City of Everett

MEMORANDUM

RE: Everett White Paper Requesting Appendix 2 Required Actions related to Monitoring be Removed-2024 Western Washington Phase II Municipal Stormwater Permit Reissuance Comments

**Figure 1
Marshland**

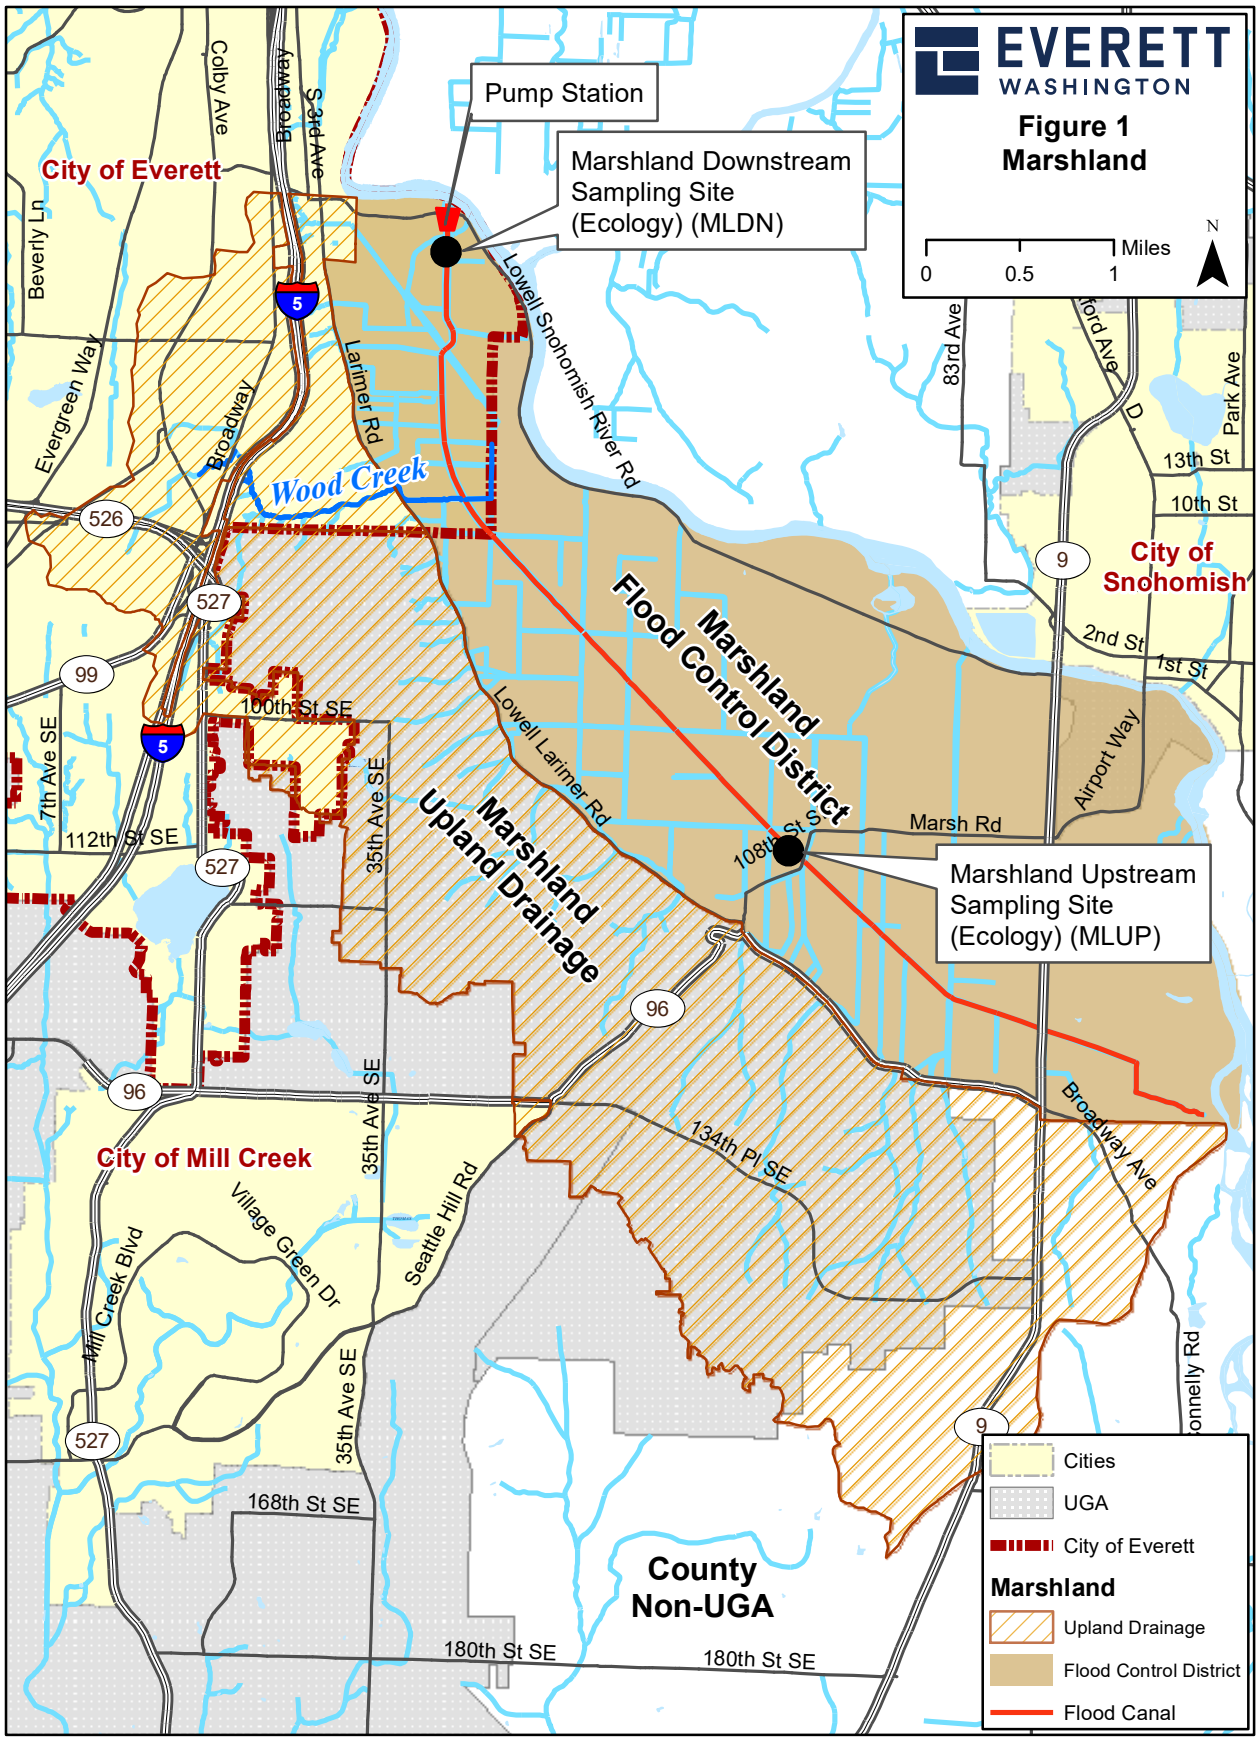
Within the City of Everett, flow from the City MS4 to the Marshland Watershed is primarily via Wood Creek (Figure 1). Wood Creek is the only tributary within the City that has perennial flow draining to the Marshland Watershed segment, as a result Wood Creek is the waterbody sampled to meet this surface water monitoring "Action Required". The City has sampled Wood Creek since 2007 as part of the required Permit Special Condition S7 TMDL compliance monitoring. The City's TMDL sampling per Appendix 2 has continued to demonstrate that Wood Creek is not a source of fecal coliform bacteria to the Marshland segment.

The City of Everett does not have an MS4 directly connected to the Marshland Watershed Segment, XW79FQ (Figure 2). In addition, the Marshland Flood Control District manages the system of canals and ditches. The "Actions Required" in Appendix 2 need to have an established tie to the permittee's MS4 ownership and operational responsibilities. In this case, Everett does not have MS4 discharging into the Marshland Watershed Segment and the Marshland watershed segment is controlled and operated by the Marshland Flood Control District. Wood Creek, which the City does have MS4 contribute to, has shown since 2007 not to be a source of fecal coliform bacteria to the Marshland Watershed. Any monitoring not associated with the MS4 is requested to be removed from Everett's Actions Required.
